Ford / Jaguar / Seat / VW
Cougar, Galaxy, Mondeo, X-Type, Alhambra, Sharan

CLTB 0010

MODIFICATION TO FORD CSC BCS119

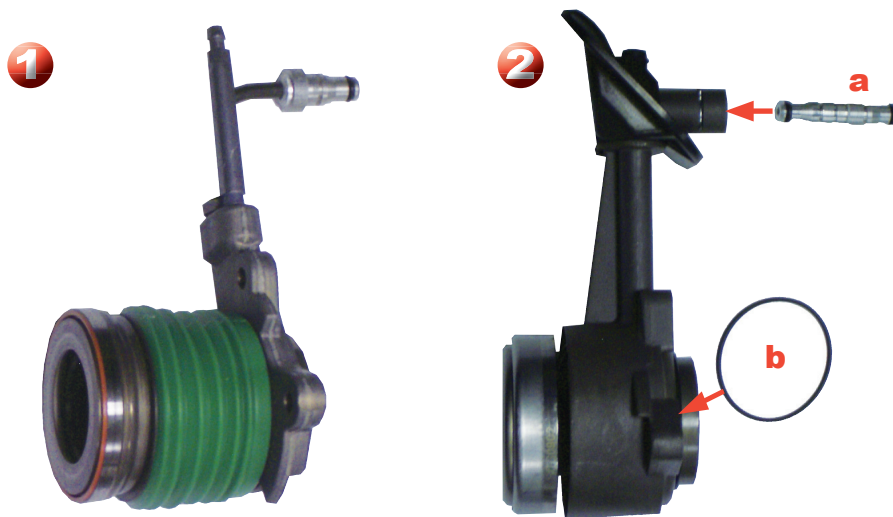
The vehicles listed above were originally fitted with a Concentric Slave Cylinder (CSC) designed and manufactured by FTE (1) and incorporating a male push type hose connector. An alternative unit manufactured by LUK (2) with a female type hose connector is also suitable for fitment by using the the adaptor pipe (a) supplied inside the carton.

IMPORTANT - please ensure that the o-ring supplied (b) is fitted as shown.

When fitting the new CSC please ensure that the gearbox location mounting face is clean and free from any damage.
